A-6297 (Special Permit Request)

CHEVY CHASE VILLAGE
BOARD OF MANAGERS
MAY 13, 2013 MEETING
STAFF INFORMATION REPORT

SUBJECT: HEARING OF APPEAL CASE NO. A-6297 SPECIAL PERMIT REQUEST
MR. & MRS. JERRY PRITCHETT 5607 PARK STREET
REPLACE AND WIDEN A CONCRETE DRIVEWAY, INCLUDING A NEW PAVER BORDER, THAT WOULD MEASURE A MAXIMUM OF THIRTEEN FEET, NINE INCHES (13'-9") IN WIDTH IN THE PARK STREET PUBLIC RIGHT-OF-WAY.

(PREPARED BY STAFF)
(NOT TO SCALE)

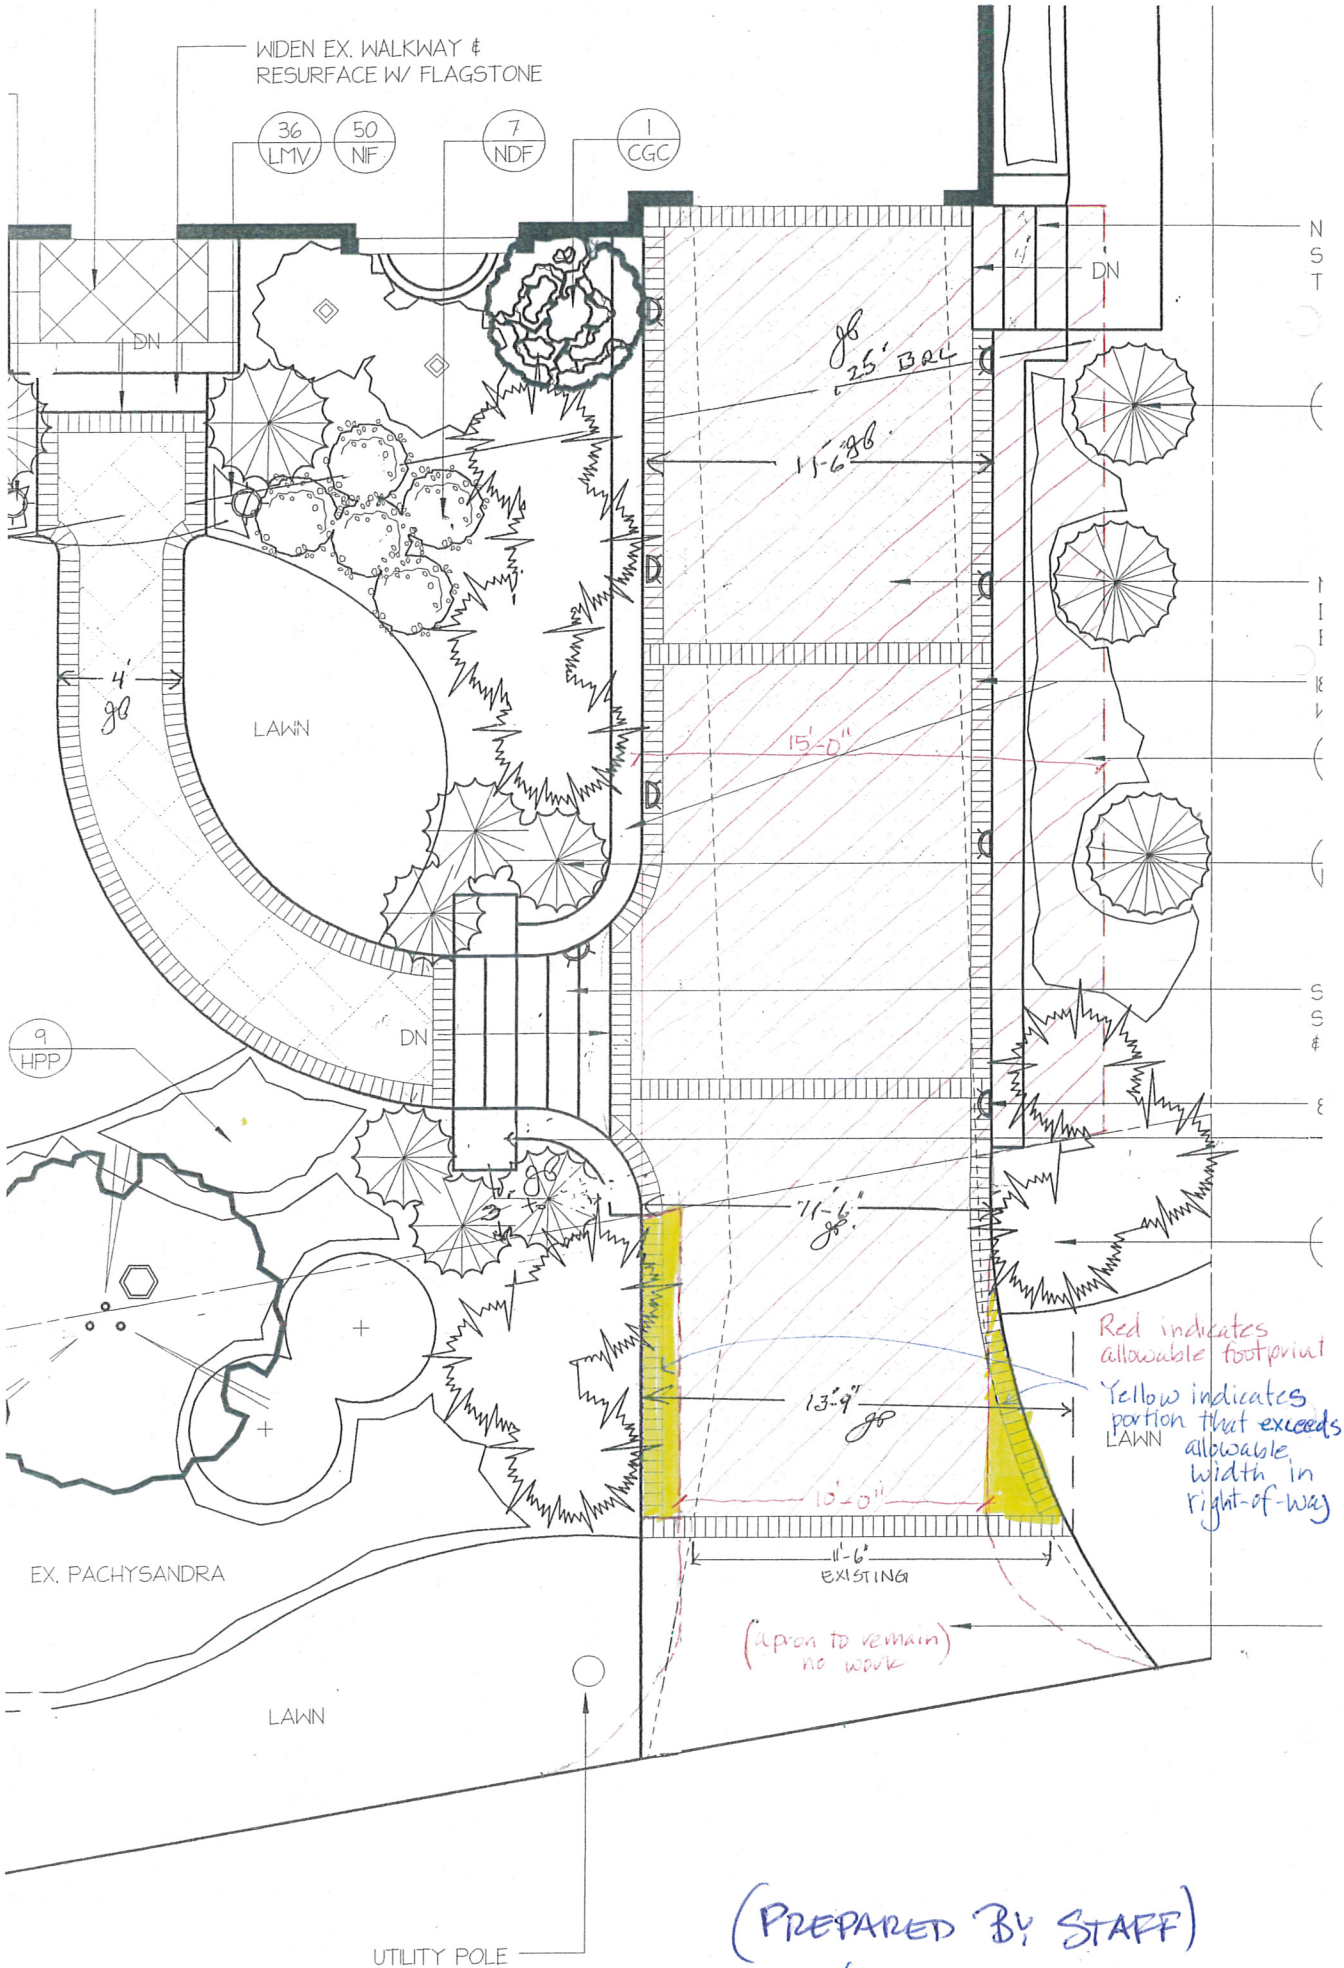
A portion of the existing driveway measures a maximum of eleven feet, six inches (11'-6") in width in the public right-of-way. The proposed driveway would measure a maximum of thirteen feet, nine inches (13'-9") in width in the right-of-way. The Code allows a driveway in this location to measure a maximum of ten (10) feet in width.[1]

The apron and the curb cut are not proposed to be widened.

A diagram of allowable and proposed widths, prepared by Village staff, is included immediately following this report.

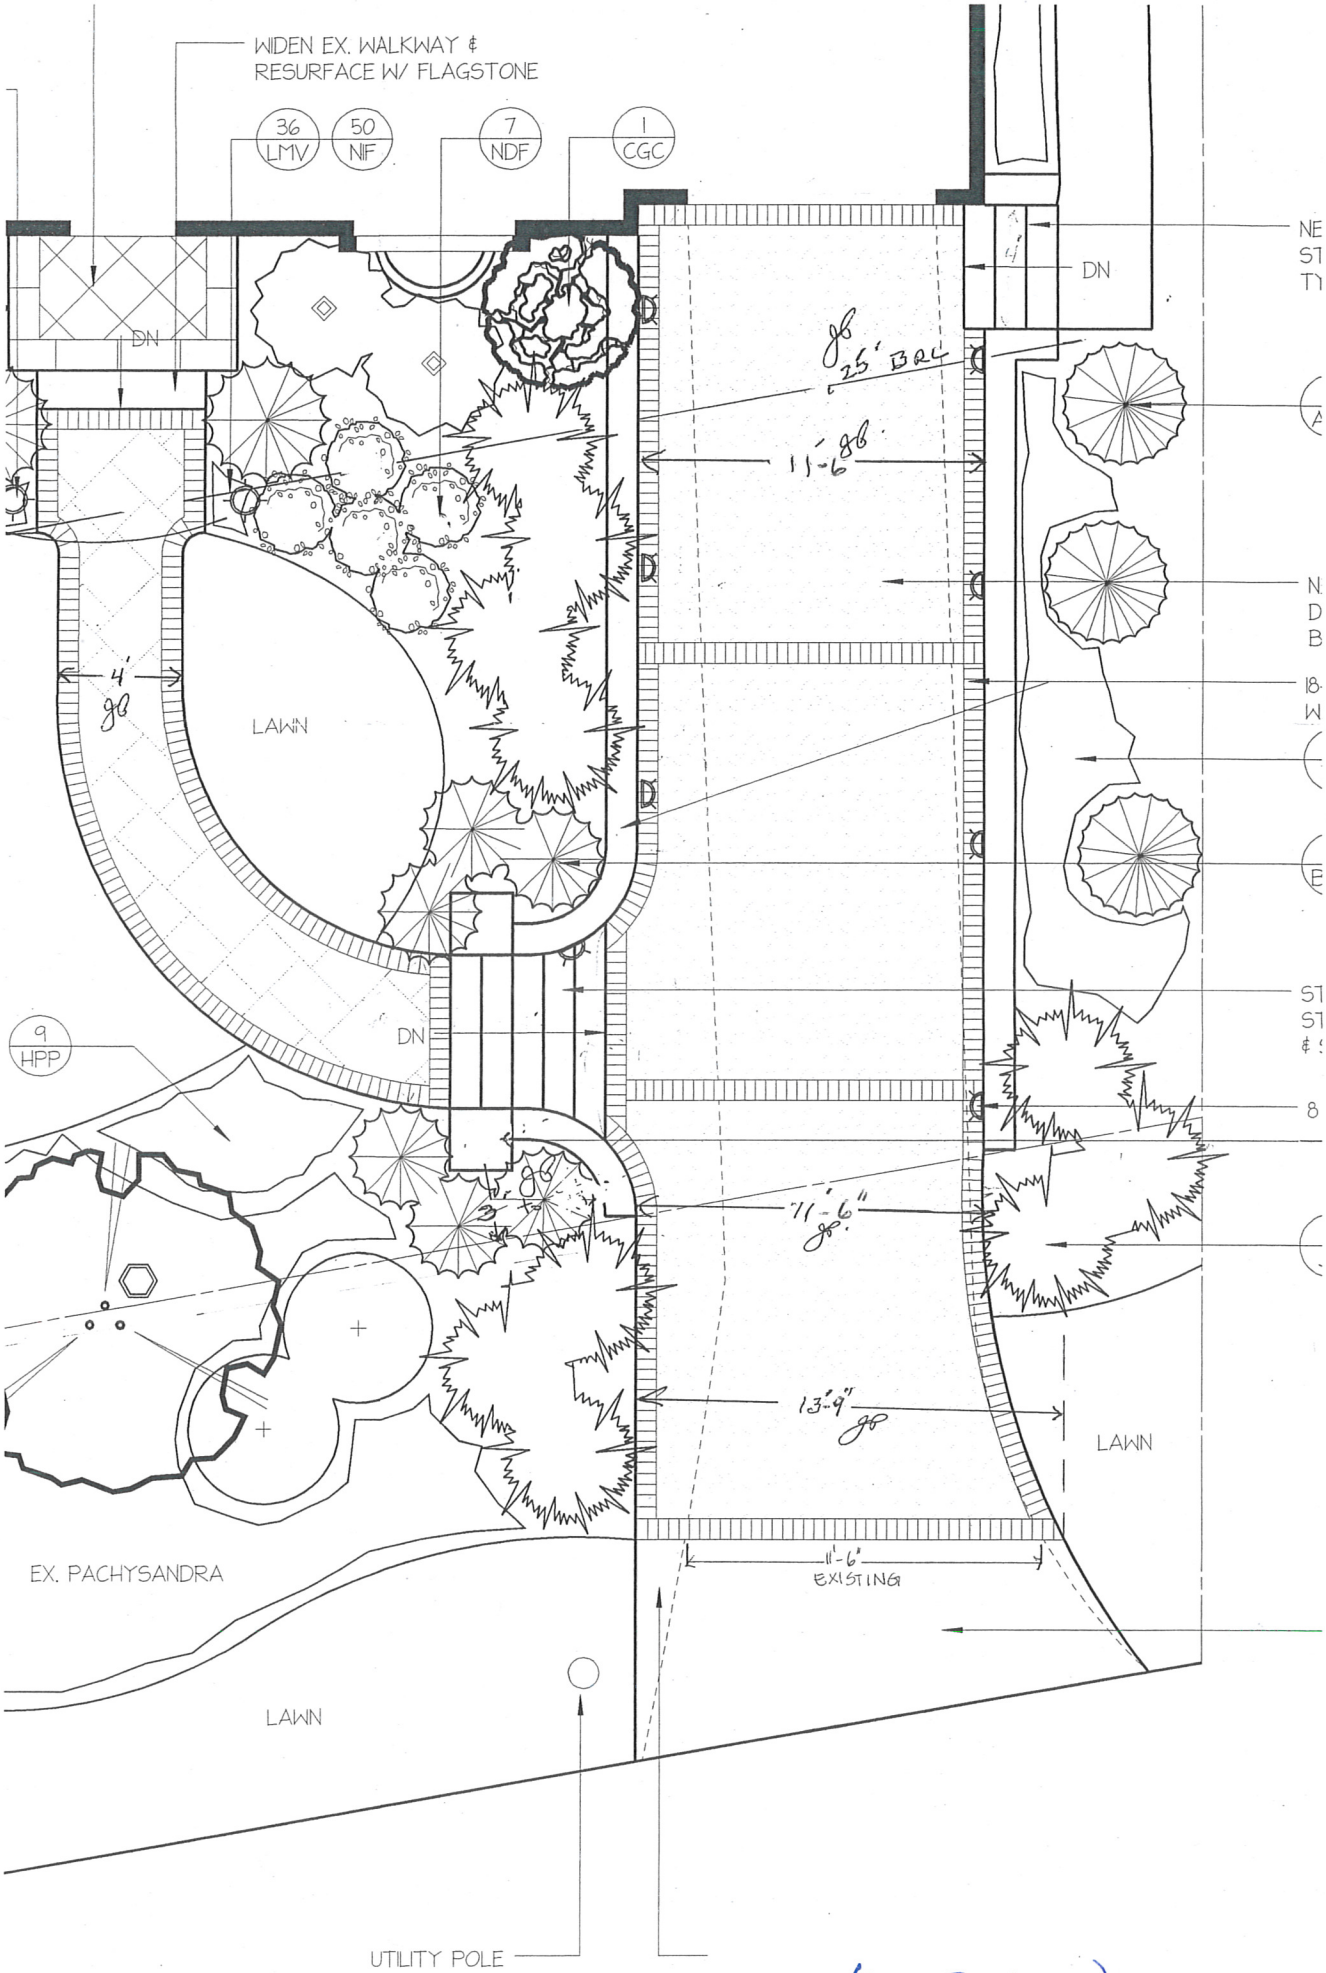
For Use By Village Manager	Application denied for the following reasons:
DENIED MAR 21 2013 Chevy Chase Village Manager	Denied The proposed driveway exceeds the maximum allowable width in the public right-of-way.
